**FREDERICK COUNTY PLANNING COMMISSION**  
**October 14, 2015**

**TITLE:** AutoZone Retail Auto Parts Store

**FILE NUMBER:** SP 84-08, AP 15453, APFO 15454, FRO 15455

**REQUEST:** **Site Plan Approval**  
The Applicant is requesting site plan approval for the construction of a 7,382 square foot retail auto parts store, on a .804-acre site.

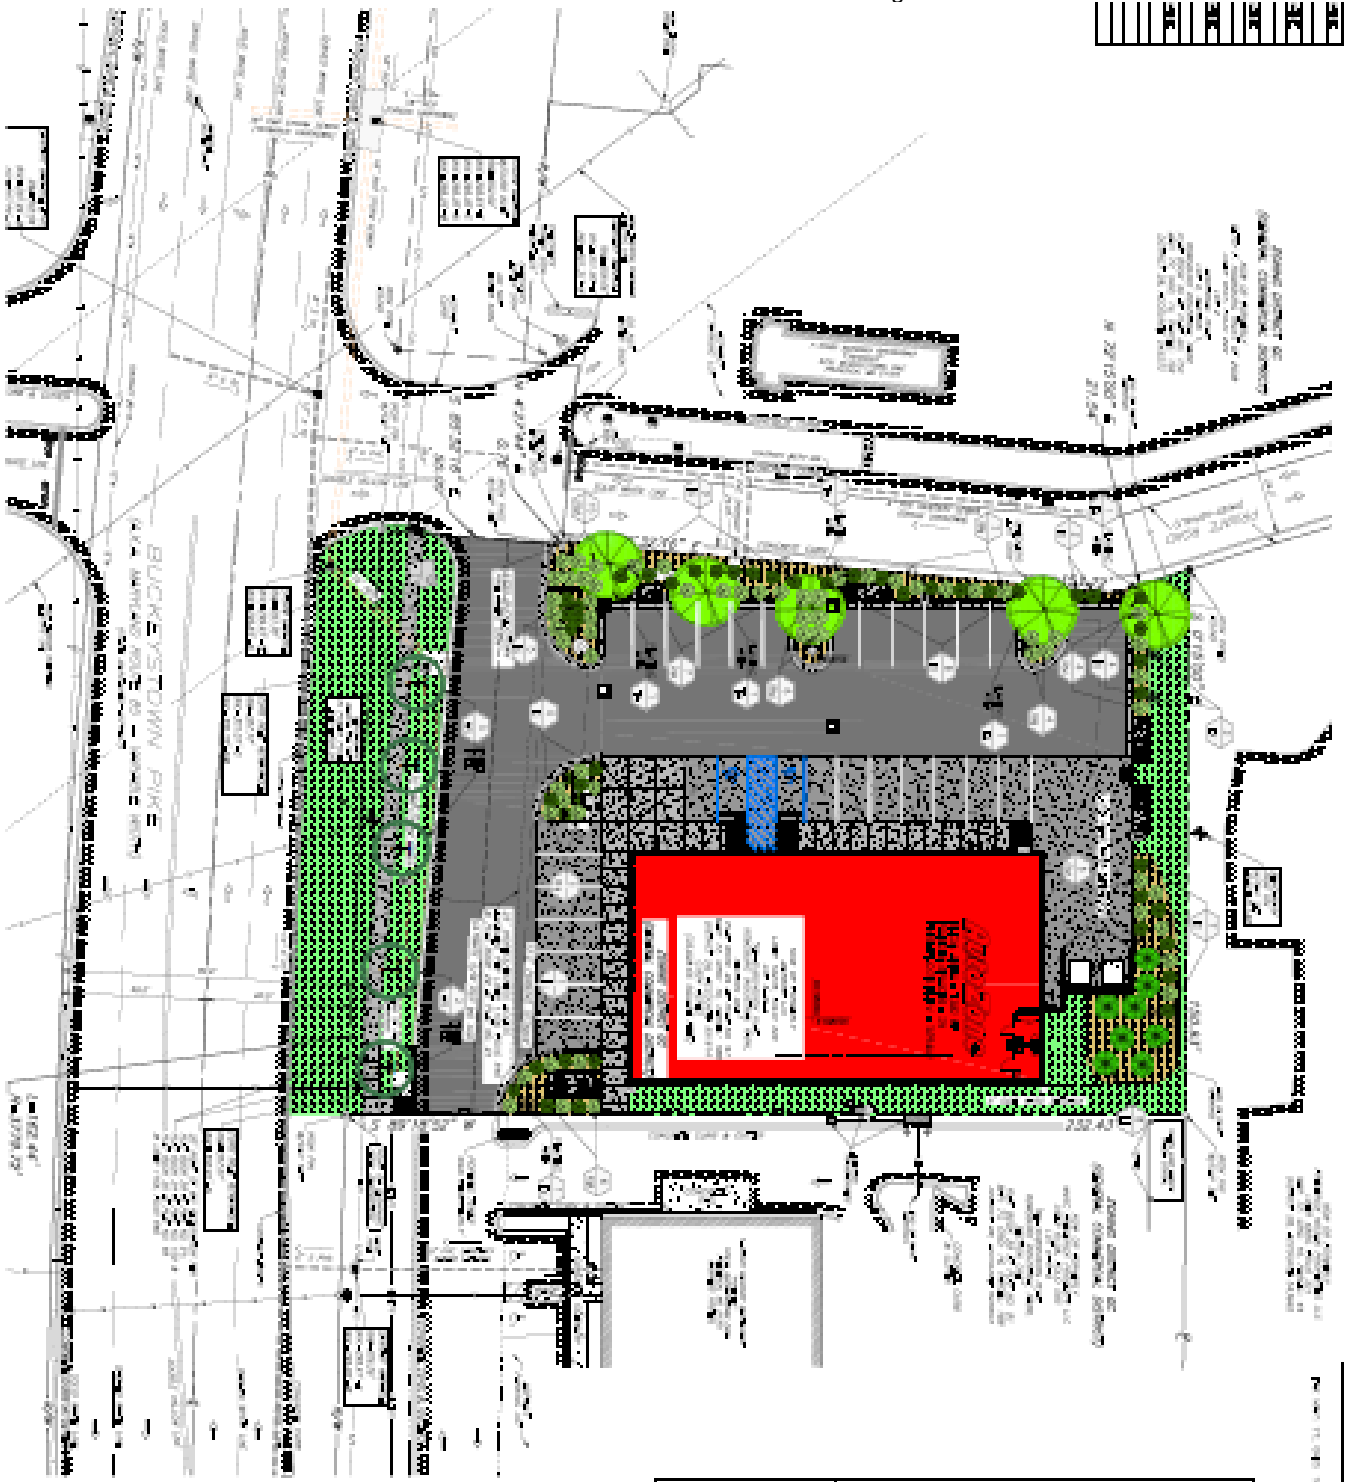
1. Address all agency comments as the plan proceeds through to completion.
2. **Parking Area Landscaping Modification (§1-19-6.400(D)(1)):** The Applicant is requesting approval to allow the elimination of a landscaped island at the end of the parking area along the building near the loading area to accommodate the necessary truck turning area for deliveries. The Applicant is also seeking a modification to eliminate the landscaped island tree requirement at the south-western corner of the building due to a water meter vault.

3. **Lighting Modification (§1-19-6.500.(D)):** The Applicant is requesting a modification from the requirement to limit light spillage to 0.5 foot candles at the property line in the southwest corner of the building and the northeastern most lot light.
